VILLAGE OF GERMANTOWN
N112 W17001 MEQUON ROAD
GERMANTOWN, WI 53022

MEETING:	PLAN COMMISSION
DATE AND TIME:	<u>MONDAY, APRIL 11, 2016 6:30 p.m.</u>
LOCATION:	Germantown Village Hall Board Room

4/11/16 Plan Commission Meeting

Village Planner Report

SHEET 1 OF 4

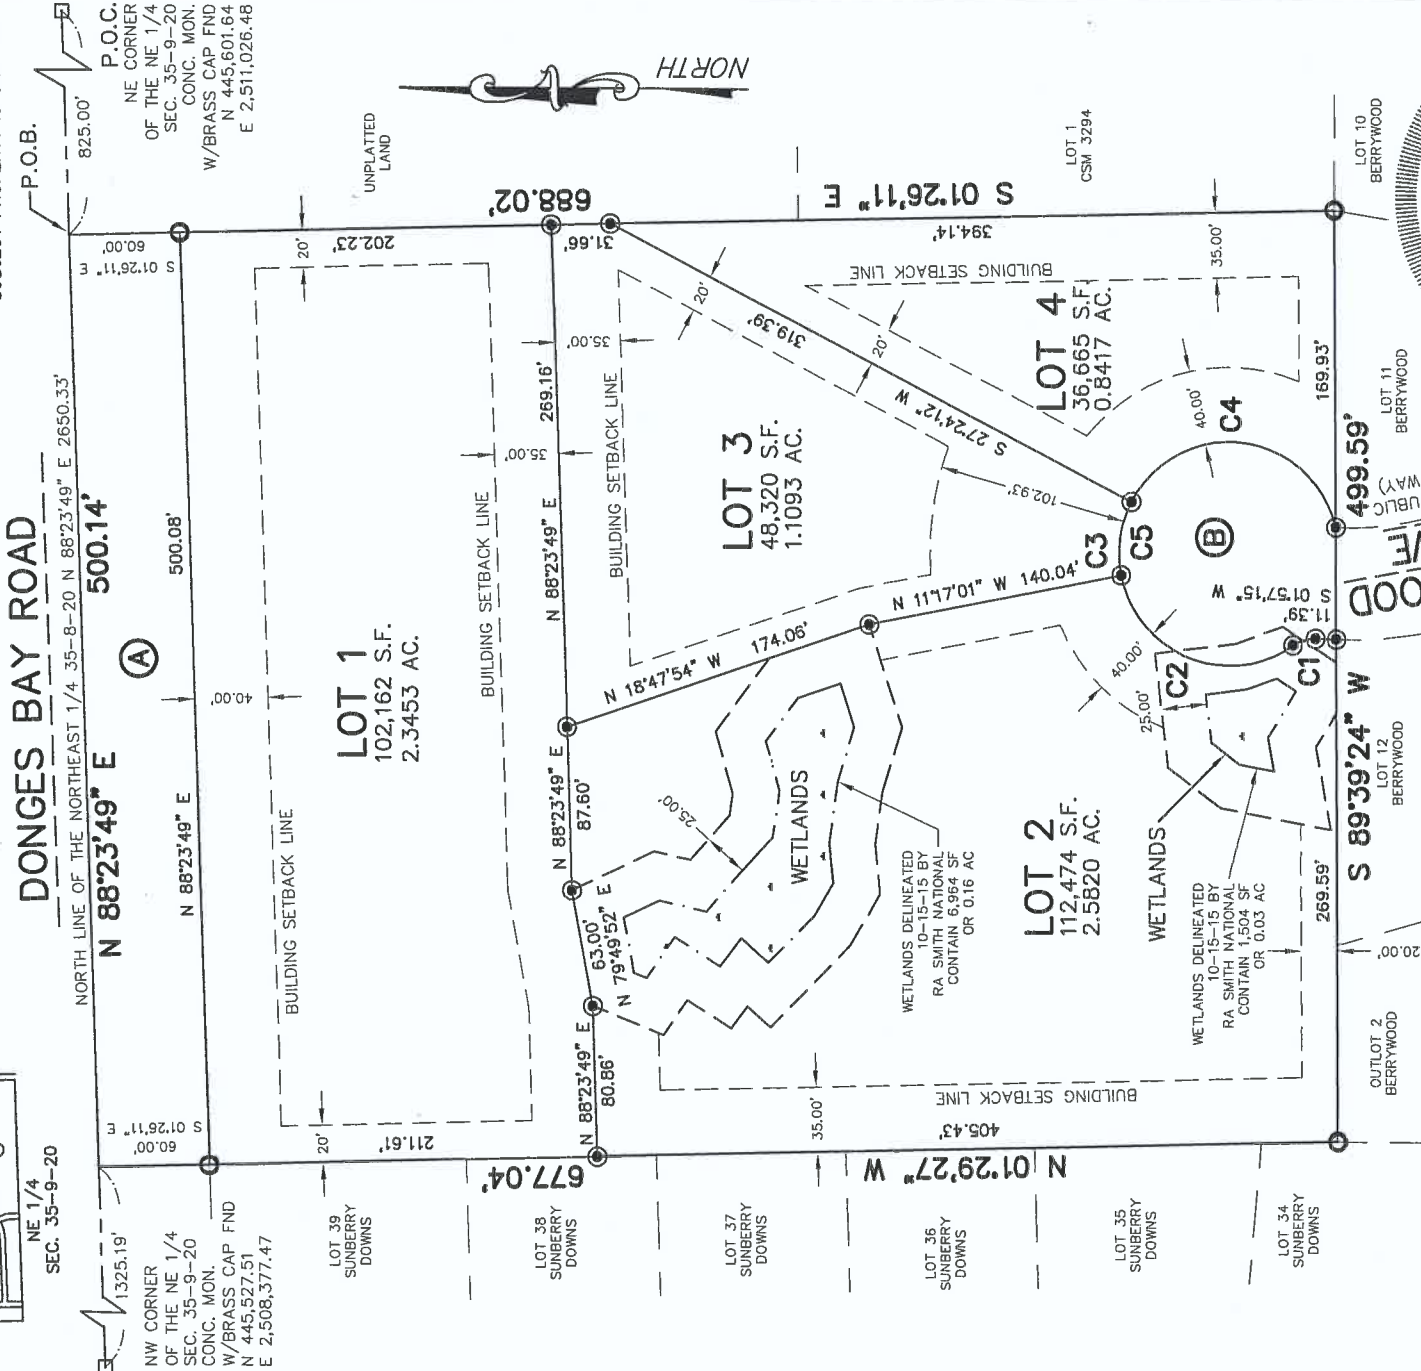
1. The planning commission secretary is Lori Johnson. This item has not been revised.
2. The Village no longer requires the line tables for the wetland delineation as shown on sheet 3 of 4 as long and the wetland lines are tied to either existing or proposed lot lines with a bearing and distance. The surveyor can remove these tables if need be. This item has been revised
3. Termination of Gatewood Drive to be determined after I receive a copy of the CADD file from the surveyor and can show a proposed offset bulb. This item has been revised
4. Revise Owner and Village Board certificate to reflect text in red shown below:
These items Owner and Village Board approval certificates has not been revised.

5. There needs to be a 3"x3" square reserved in the upper right corner of Sheet 1 for recording data purposes at Washington County Register of Deeds Office.

6. While the 25' wetland setback line is shown, there is no label defining what the line represents. This needs to be addressed.
7. The developer needs to provide construction plans prepared by a professional engineer, in compliance with the Village Standard Specifications for Development and Construction and specifically for the following items:

Site Plan - Overall

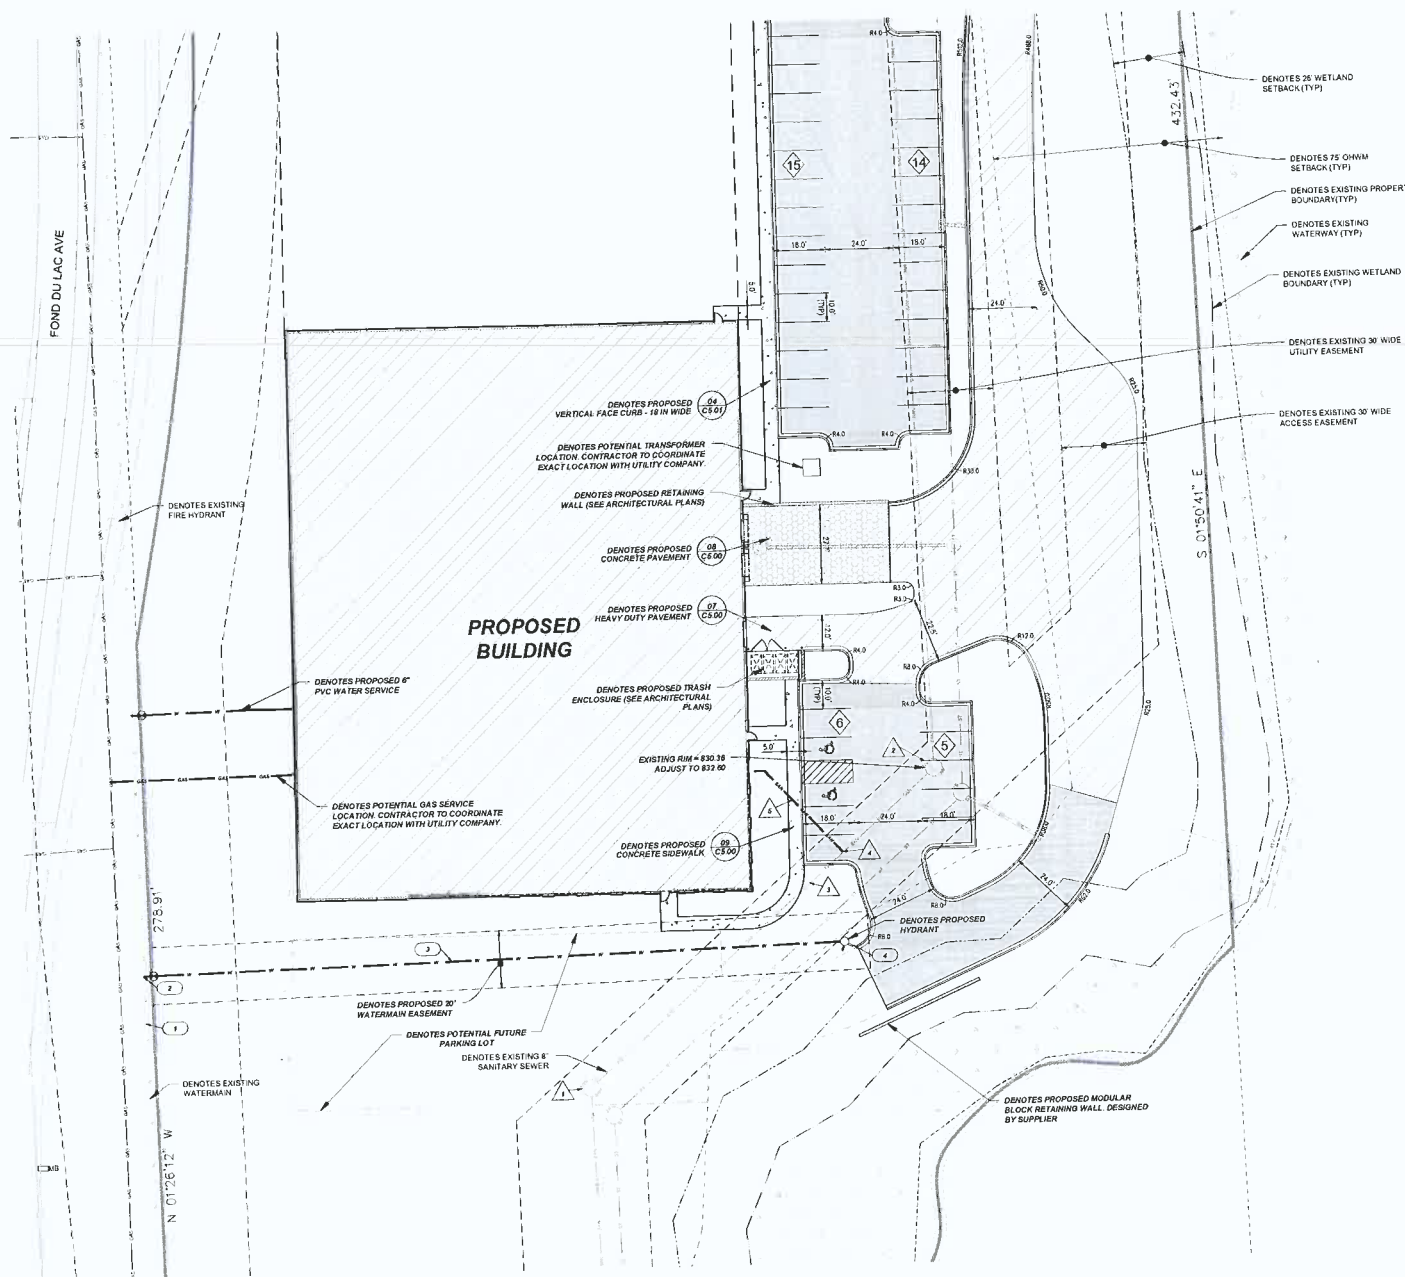
1. Provide additional Fire Department access from Main Street or Fond du lac Ave;
2. Provide marked exit paths to at least two (2) additional exit doors or gates that will open with egress on emergency exiting on fencing;
3. Outdoor areas are regulated by the IBC (building code) Chapter 10;
4. Concerns are for illuminated exit and emergency lighting;
5. Occupant load sign required outside and in building;
6. Provide a location for a portable cooking grill or trailer;
7. Provide a guard rail, bollards or parking curb stops to help prevent vehicle damage to fence.

SHEET 3 OF 7

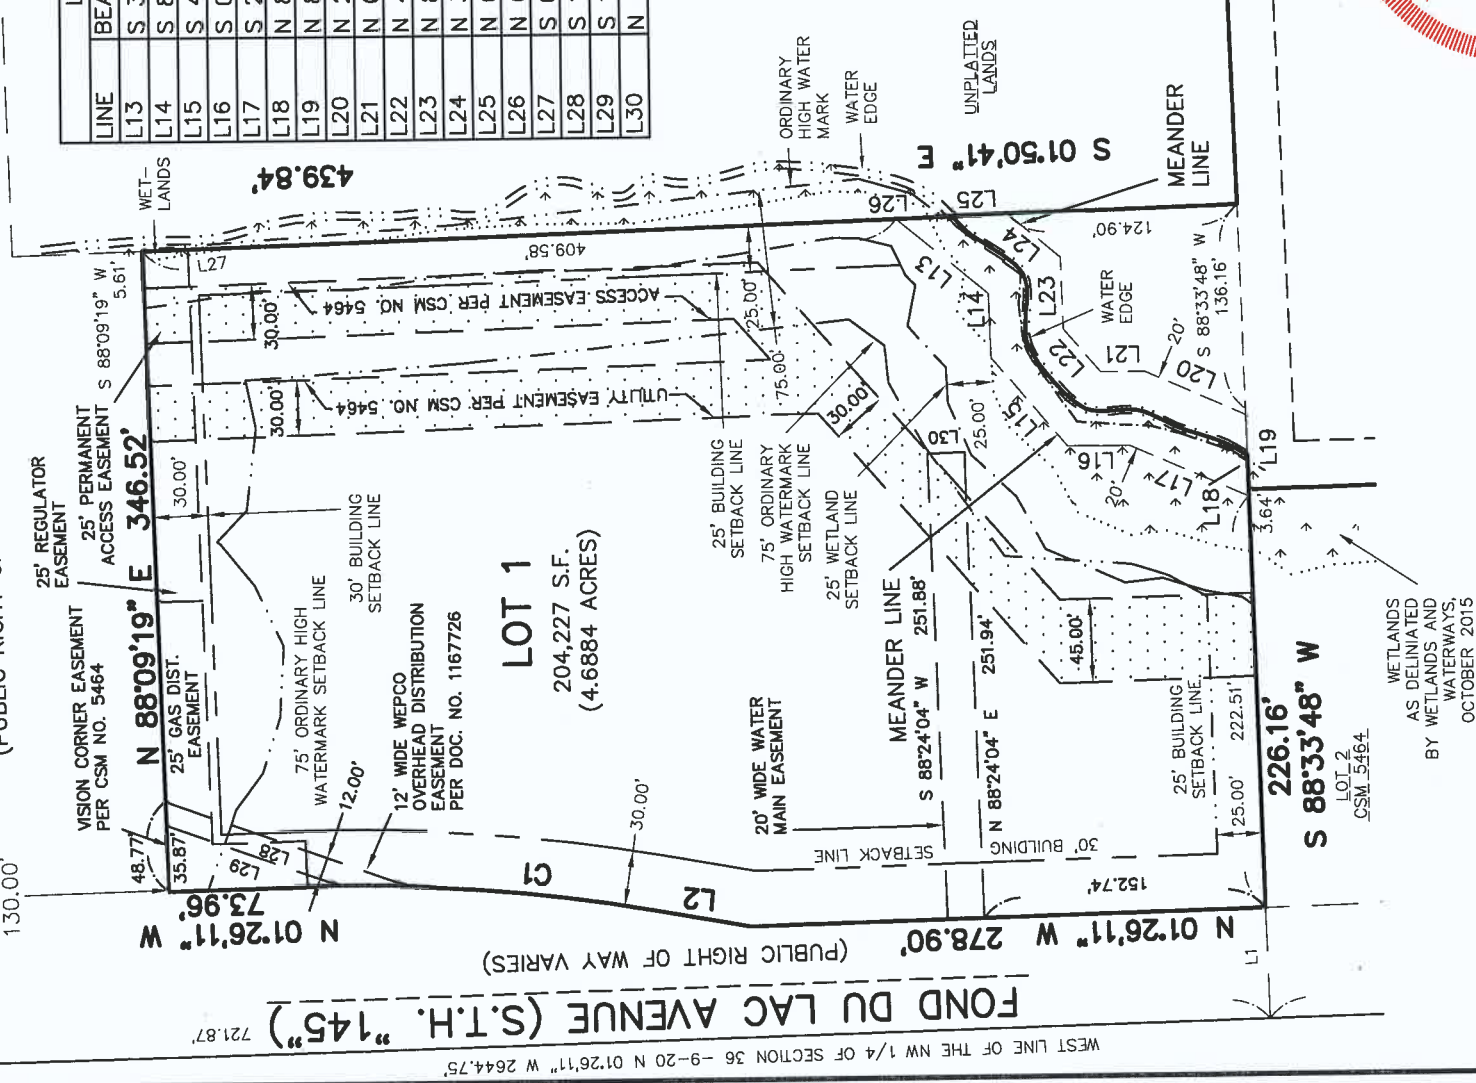
1. Lot 1 of Certified Survey Map No. 5464 no longer exists as stated in the sheet headers for sheets 1 thru 6 and in the Surveyor's Certificate due to a fee simple taking of lands by the Wisconsin Department of Transportation along STH-145 and along Donges Bay Road by R/W plat.

A new metes and bounds legal description will be required for the Surveyor's Certificate on Sheet 2 of the exterior boundary of the lands being divided.

3. The Village no longer requires the line tables for the wetland delineation as shown on sheet 2 of 6 as long as the wetland lines are tied to either existing or proposed lot lines with a bearing and distance. The surveyor can remove these tables if need be.

6. The map sheets submitted do not scale as does the graphics scale on Sheet 1. Addressed
7. The graphics scale appears to have some annotation issues as the scales go from 0 to 100' to 100'. Check your block. Addressed
8. The bearing of the west line of the Northwest $\frac{1}{4}$ of Section 36, Township 9 North, Range 20 east is North 01°26'11" West and needs to be adjusted as well as the west line of Lot 1. Also will this adjustment reflect in all of the bearings? Addressed
9. According to the bearing basis described on sheet 1, the west line of CSM No. 5464 was used as the basis, but according to the legend, no original boundary corners from that CSM were recovered. It is recommended that the north or west lines of the quarter section be used as a bearing basis as a reference.

10. A R/W dimension from line L3 to the west line of the $\frac{1}{4}$ sections needs to be added. Addressed
11. The smaller text notes or numbers need to be increased in size to meet the County Register of Deeds recording, scanning and archival requirements. The minimum font or text size is 10 pt or L100 in a Leroy font. Addressed
12. There is a note on Sheet 1 referring to the meander line detail on Sheet 3, but there is no mention or designation of a meander line on Sheet 3. Addressed
13. There is a utility easement shown along the north and east line of proposed Lot 2 that does not follow the same alignment or location as shown on CSM 5464. The easement line along the east boundary is converging into the RR right of way line instead of running parallel to it as indicated on CSM 5464.

23. There needs to be a 3"x3" square reserved in the upper right corner of Sheet 1 for recording data purposes at Washington County Register of Deeds Office. Addressed
